BYLONG COAL PROJECT

Environmental Impact Statement Supplementary Response to Submissions

August 2016

SUPPLEMENTARY RESPONSE TO SUBMISSIONS

Figure 6
Historical Mining Contributions Compared to UK DEFRA Criteria

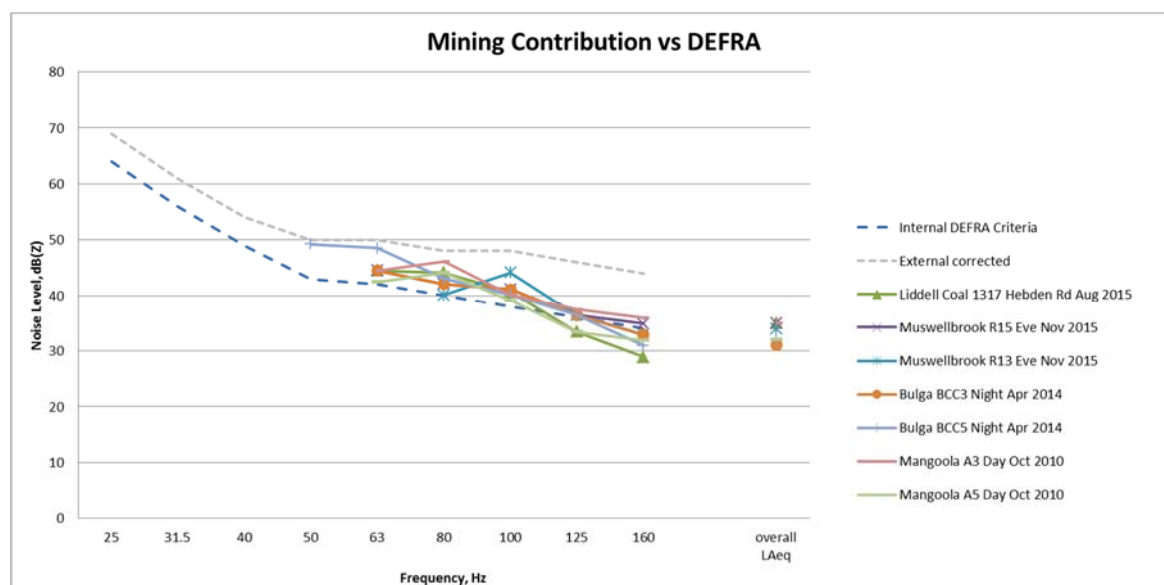
A selection of measurements where a low frequency noise contribution was identified as audible were collated for comparison. The monitoring reports measured noise in the A weighted spectrum with a 20 dB lower limit, monitoring results below 63 Hz were typically not available for comparison. Measurements where other significant noise sources (such as road traffic) potentially contributed to the measured noise levels have been excluded.

The comparison demonstrates that external noise levels generated by mining operations as recorded at neighbouring receivers would comply with the UK DEFRA low frequency criteria when the criteria has been corrected for transmission loss.
